## **PLANNING DEPARTMENT REPORT**

### **YARMOUTH, MAINE**

Request for a Waiver of the Technical Standards and Approval of an Accessory Dwelling Unit

636 North Road

Renovated Floor Plan

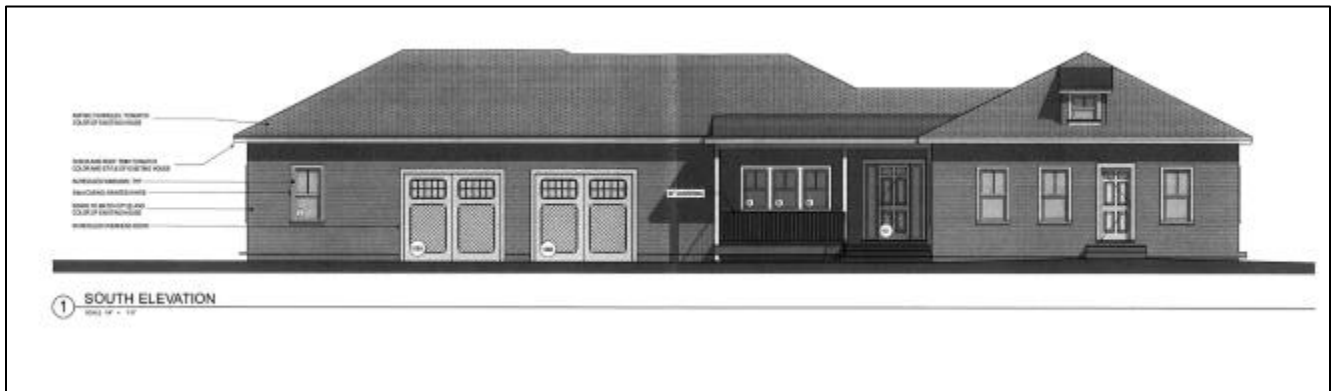
Town Comments: The applicant has already completed renovations of this structure and provided a floor plan depicting all required elements.

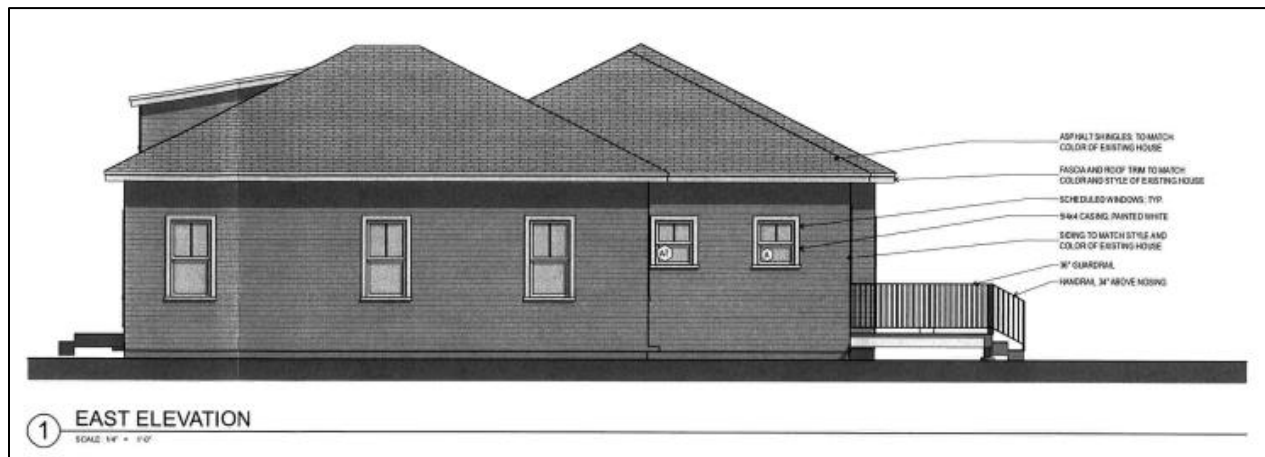
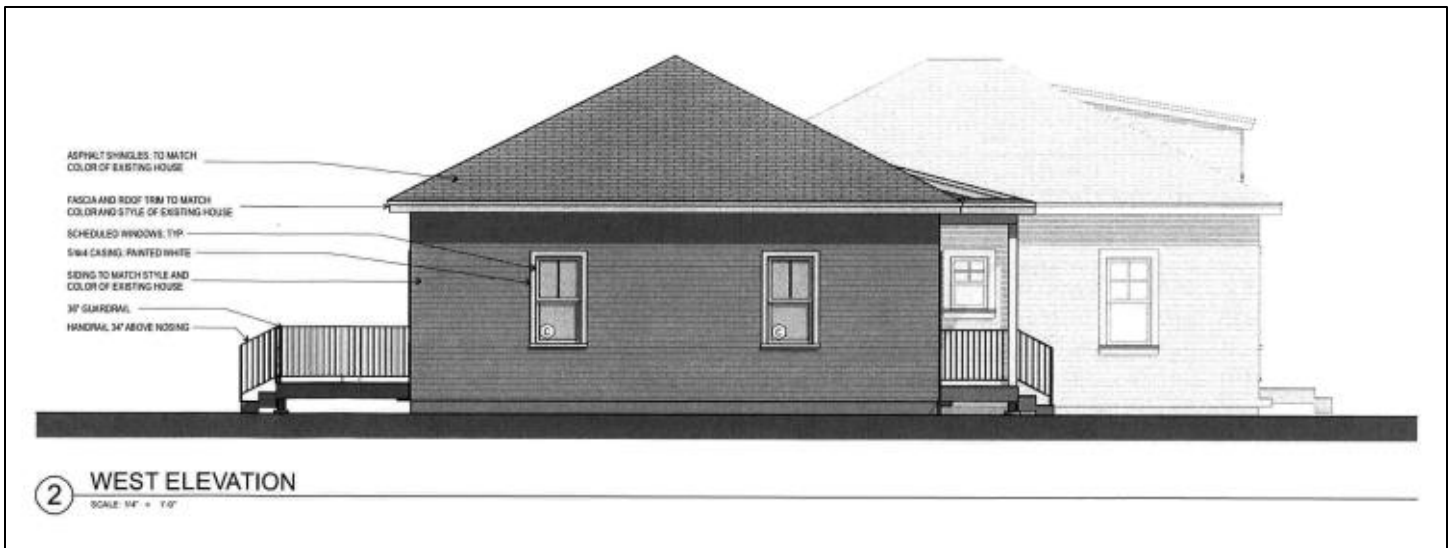
Town Comments: The renovation does not alter the exterior design of the structure facing east to North Road and minimally changes the southern view with a new covered porch. The rear of the home (north facing) is the only façade that has changed in size and the addition of the rear deck. Therefore, the proposal is in harmony with and maintains the scale of the neighborhood.
